**1958 Agreement – Consideration of draft amendments
to existing Regulations submitted by GRSP**

Proposal for Supplement 10 to the 04 series of amendments to Regulation No. 44 (Child restraint systems)

Submitted by the Working Party on Passive Safety *

Figure 1
Procedure type 1

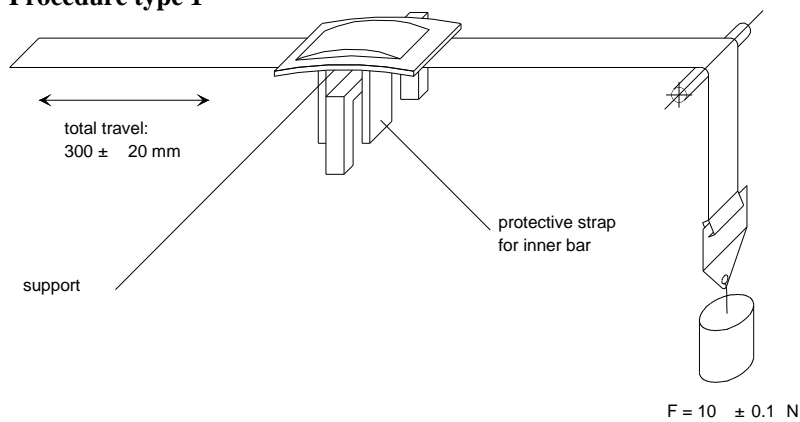
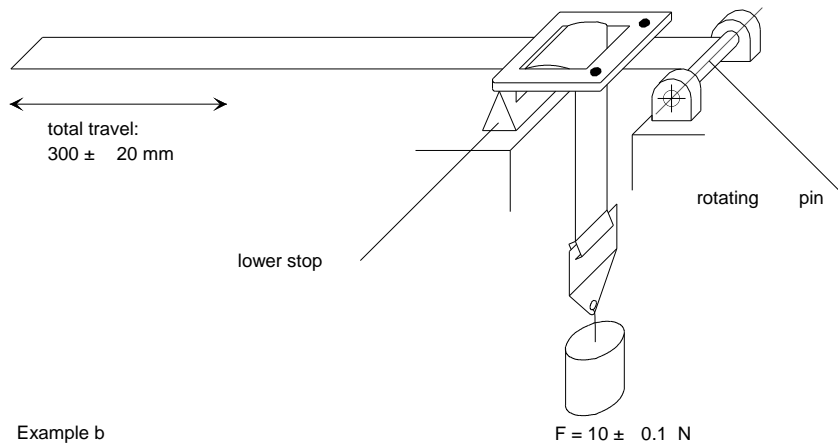
Annex 5, amend to read:

Remark. $F = 10 \pm 0.1 \text{ N}$, can be increased up to $F = 60 \pm 0.5 \text{ N}$

8.2.5.2.6.3.1. Type 1 procedure: for cases where the strap slides through the quick adjusting device. Apply a load of 10 N, if necessary the load may be increased by 10 N steps so as to permit correct sliding, but limited to a maximum of 60 N. This load shall be vertically and permanently applied on the straps. The part of the strap set horizontally shall pass through the quick adjuster it is fitted to and shall be attached to a device, giving the webbing a back and forth motion. The quick adjusting device shall be so placed that the horizontal strap of the webbing remains under tension (see Annex 5, Figure 1). Activate the quick adjuster while pulling the straps in the direction to slacken the harness and deactivate it while pulling the straps in the direction to tighten the harness.

Figure 2
Procedure type 2
Following two examples of test set up;
Example 1

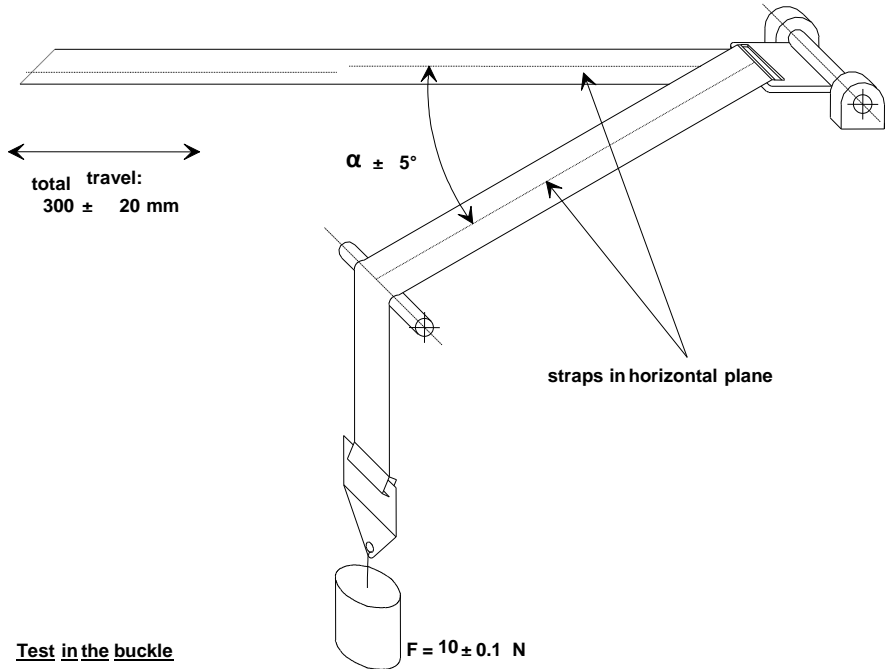
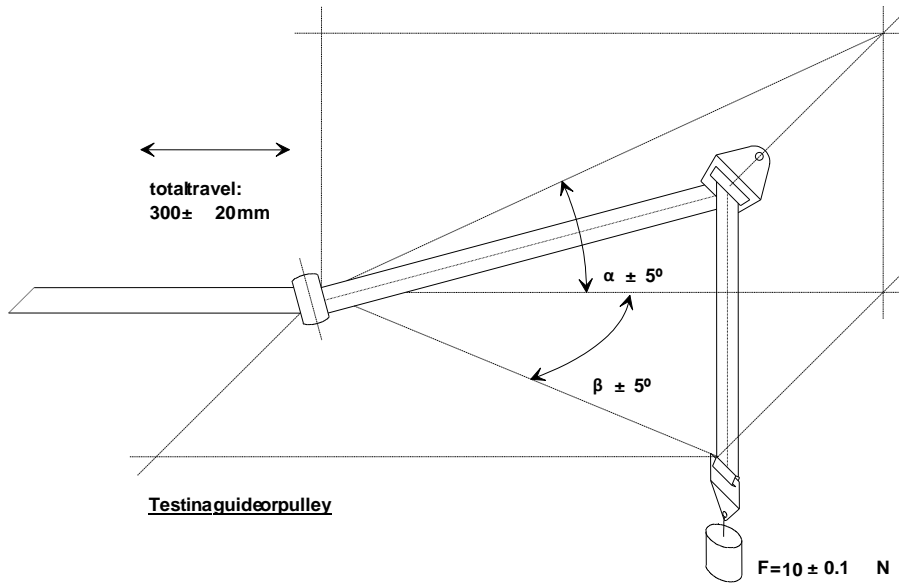
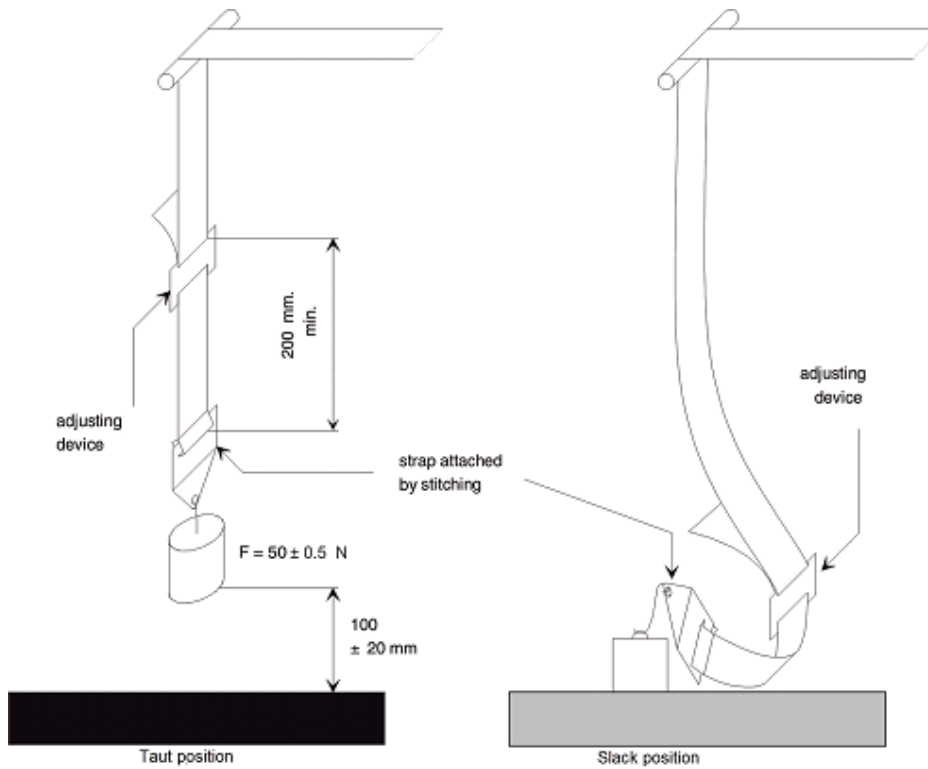
Where α and β reproduce the angles as in the real installation (in three dimensions).

The load of 50 N on the testing device shall be vertically guided in such a way as to prevent load-swing and twisting of the strap. The attaching device shall be fixed to the load of 50 N in the same manner as in the vehicle."

part it is intended for and the test set up shall reproduce the angles as in the real installation (in three dimensions), see Annex 5, Figure 2 for examples. The 10 N load shall be permanently applied. For cases where the strap changes direction more than once in passing through a rigid part, the load of 10 N may be increased by 10 N steps so as to permit correct sliding and achieve the prescribed 300 mm of strap movement through that rigid part."

Figure 1
Examples of completely recessed support leg

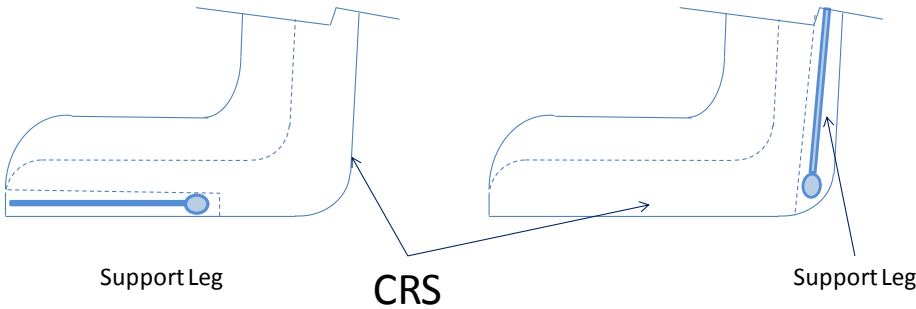
Completely recessed means that with the leg in the stowed position, no part of the leg protrudes beyond the surface of the base or shell, such that it has no effect on the position of the CRS on the test bench. See the following figures for clarification examples.

- "7.1.4.1.10.1.2. Without the anti-rotation device in use. If the anti-rotation device is a support leg and it can be completely recessed within the base or the shell of the CRS, the test is conducted with the device in its stowed position or with the leg removed respectively. If it cannot be completely recessed within the base, the test is performed with the device deployed in its shortest length with the trolley floor pan in its lowest position.
